TECHNICAL PUBLICATION INFORMATION

MODEL	F75C
SUBJECT	SERVICE MANUAL CORRECTION

Applicable Service Manual
6BC-28197-5K-11

<Figure of step 4-5 (Right column)>

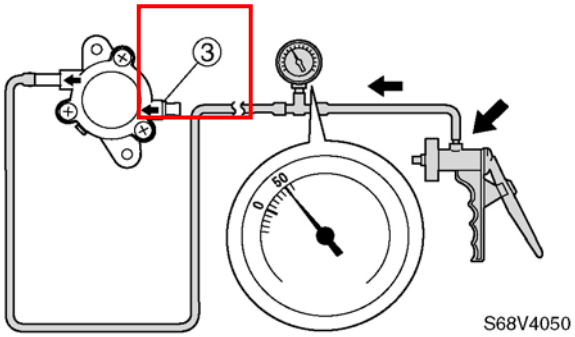
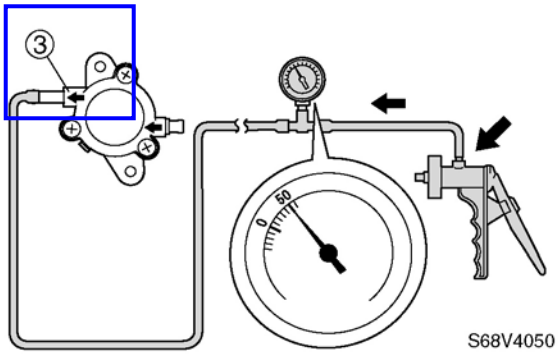
Incorrect information was included in the current Service Manual.
Please make an appropriate correction using the information that is provided herein.

INCORRECT

Checking the fuel pump

Fuel pump outlet ③

CORRECT

Specified positive pressure:
50 kPa (0.5 kgf/cm², 7.3 psi)

Specified positive pressure:
50 kPa (0.5 kgf/cm², 7.3 psi)
